## April 8, 2019 BOARD OF COUNTY COMMISSSIONERS ORANGE COUNTY, FLORIDA ADDENDUM NO. 1 / IFB NO. Y19-747-RC ORANGE COUNTY SHERIFF'S OFFICE COC IT SERVICES AREA REMODEL

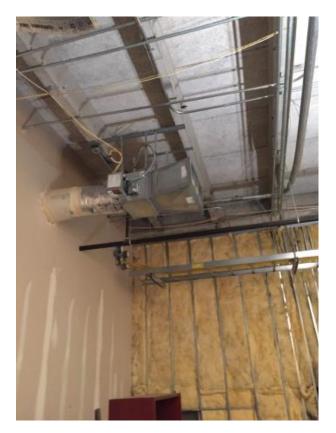
13. Question: What is the deck height above the work area?

**Answer:** Deck Height: Approximately 14'-0" based on the attached photo. Acoustical Ceiling Tiled Areas: 10'-0"
